CASE STUDY

BURNT ASH PRIMARY SCHOOL

Burnt Ash Primary School Case Study

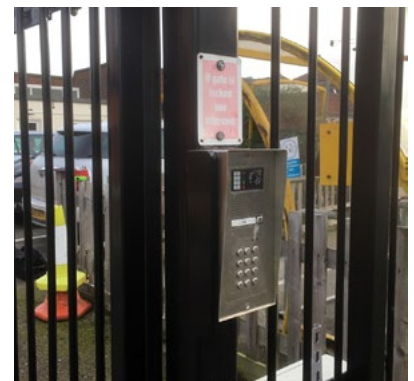
1. Risk of impact, trapping and crushing. Safety edges were only fitted horizontally to the bottom of the gate leaves on the inside of site. When tested, these edges only stopped the gates but did not revert. This represented a potential hazard since there was potential for a person to be pinned and trapped against the fence. (image 7789)

3. Risk of impact and crushing. Only two hinges per leaf were fitted, with the top hinges inverted. In the event of one hinge failing, the leaves could easily fall. The weight of the leaves is supported only by the bottom hinges as the top ones are inverted, resulting in an even greater possibility of a gate failure.

4. Risk of trapping and crushing. Large gaps were identified at hinges (over 100mm) which reduced substantially when the gates were opened. There was no evident sign of protection in this area which is subject to massive forces. The intercom outstation was mounted to the outside on the hang stile and was only reachable from the wrong side of the gates potentially causing someone to be in the most dangerous area.

5. Risk of impact and crushing. No inside photocells were fitted to cover the arc of the gates.

risk of gate crushing against a fence

inverted hinge

reducing gap at the hinge

gate features no inside photocells

Action taken: All Gate Safe's comments were taken on board and subsequently, the recommended works for upgrading the system were put out to tender.
